R E M A R K S

THE DRAWINGS

THE PRIOR ART REJECTION

FIG.8

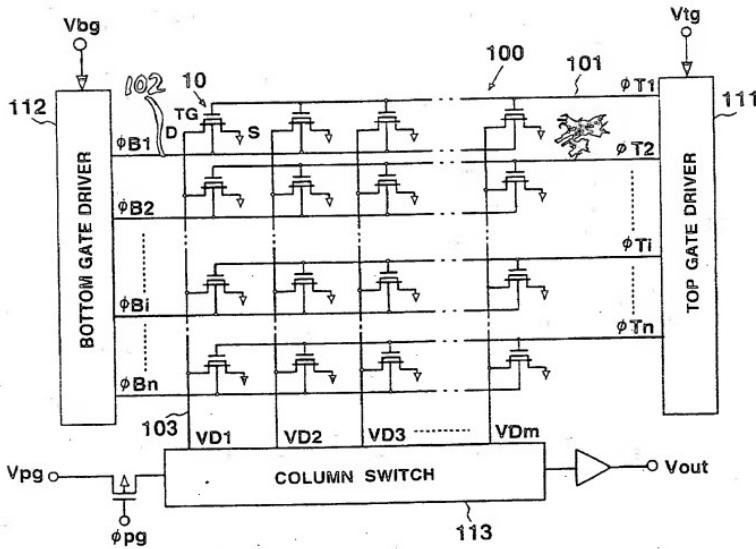
Fig. 8 has been amended as indicated in red on the attached annotated sheet to correctly identify the bottom gate line with reference numeral 102, thereby overcoming the Examiner's objection to the drawings. Submitted herewith is a corrected sheet of formal drawing which incorporates the amendment. No new matter has been added, and it is respectfully requested that the Examiner's objection to the drawings be withdrawn.
